Technical Service Bulletin: TSB110028

STC, HVT Tappet Assemblies and Rebuild Kits (T381)

Figure 5. Thick Socket Tappet

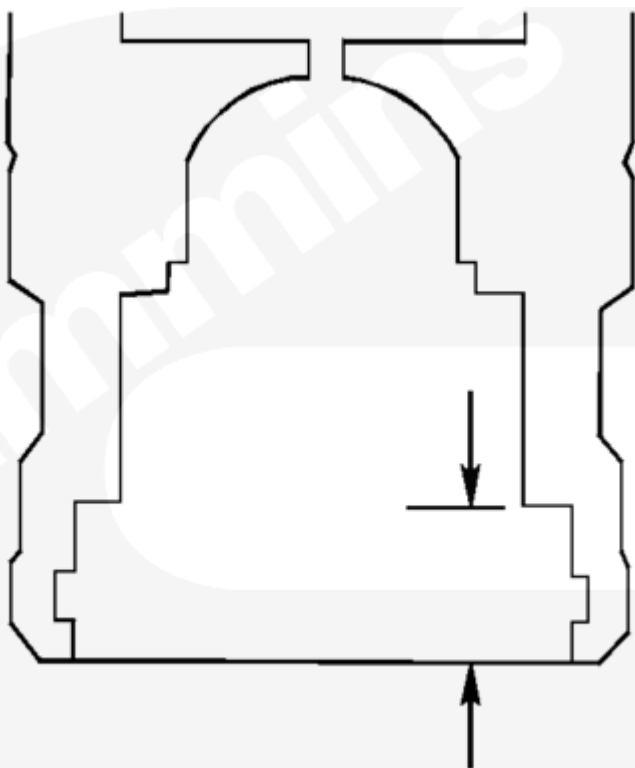
Thick socket rebuild kits are obsoleted, but they can be rebuilt with the new mushroom kit, Part No. 3804700.

Below is information on the parts that make up the current tappet rebuild kit. There is only 1 tappet rebuild kit available. The tappet rebuild kit, Part No. 3804700, contains the new "mushroom" socket and will work with **only** the thick style sockets. Thin style sockets can **not** be rebuilt and **must** be replaced.
